SEWAGE DISPOSAL SYSTEM

DEPARTMENT OF HEALTH AND MENTAL HYGIENE

REPAIR - PURPOSE - IN SUPPORT OF BUILDING PERMIT TO REPLACE AN EXISTING DWELLING THAT WAS DESTROYED BY FIRE.

RE: 2444 Mullinex Mill Road

LOCATION DIAGRAM

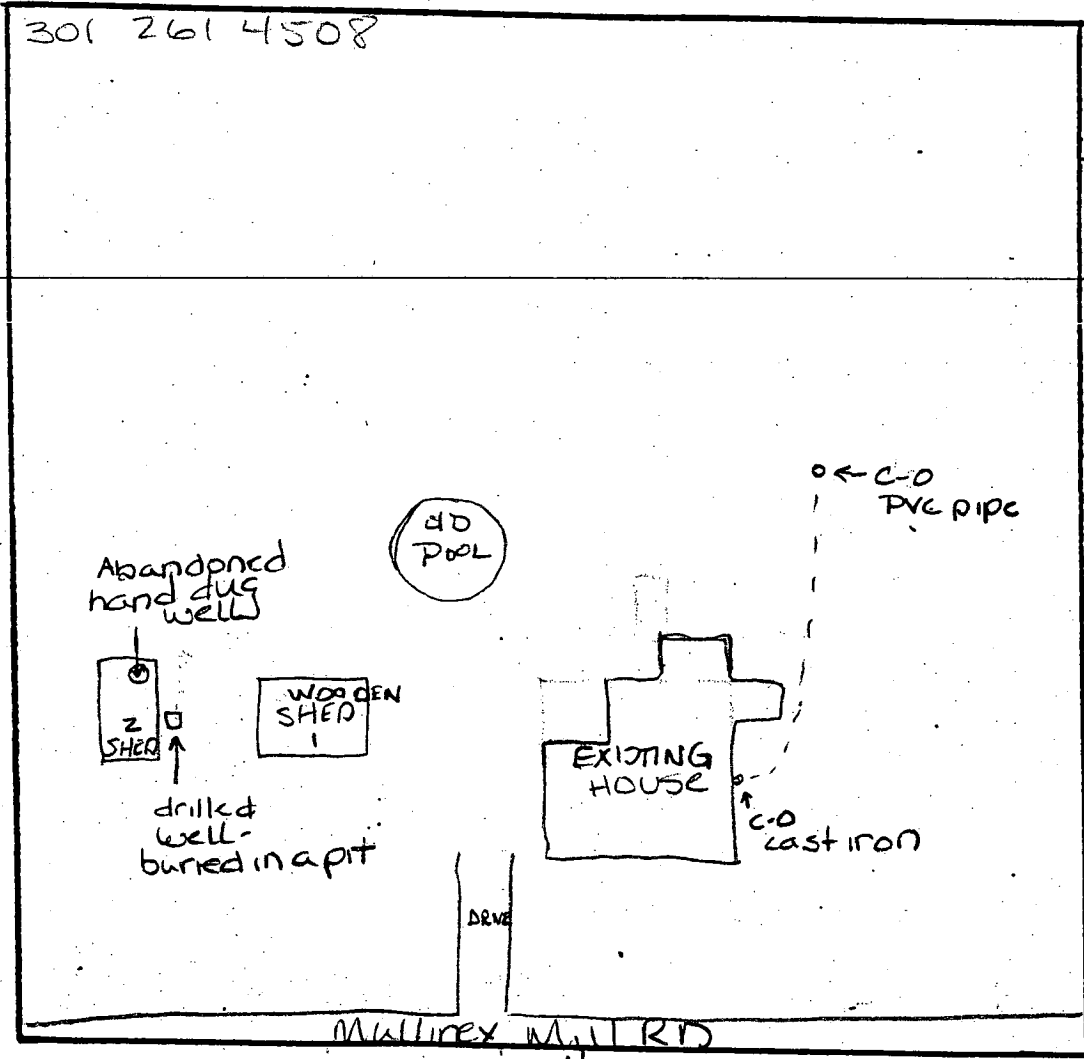
COMMENTS: 8/25/94 Tie off septic^{s well} line seal 15' from house foundation. before tearing the house down. Apply for septic repair permit. - call for inspection. Ann Met John Mueller 301 854-6104

PROPERTY OF:
EDWIN M. AND MARY I. LUDLOW
LIBER 3042 FOLIO 0125
SHOWING LOCATIONS OF:
DRAIN FIELD
EXISTING AND PROPOSED BUILDINGS.

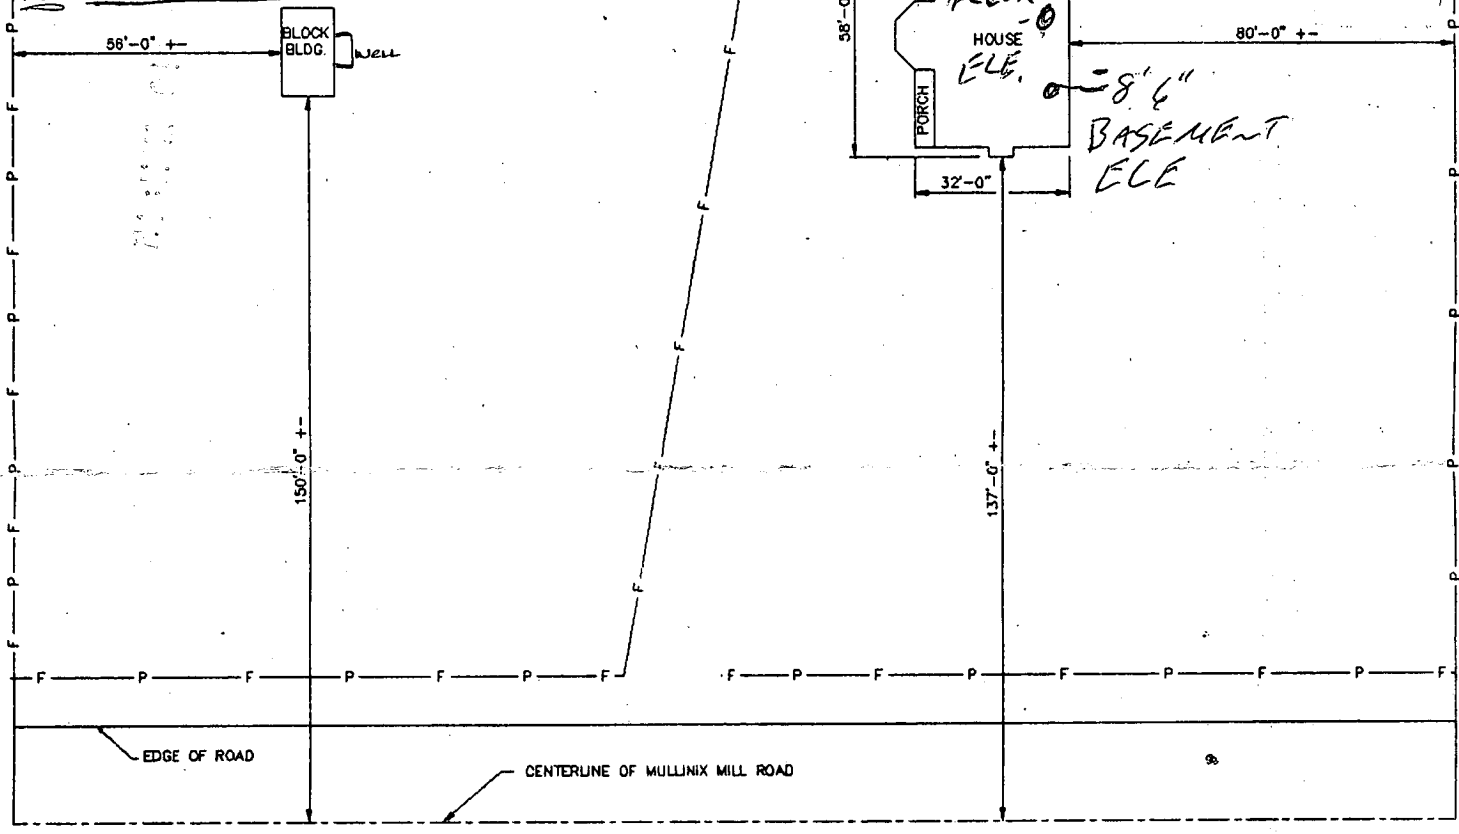
No known elevations. Builder assigned
First floor elevation of 0.0' E
Basement elevation -8.6'
Ex. elevation at house -3'
inv. elev. out of house -4
inv. elev. into ST -5

NO BASEMENT SERVICE

Approved Septic System Plan Howard County Health Department
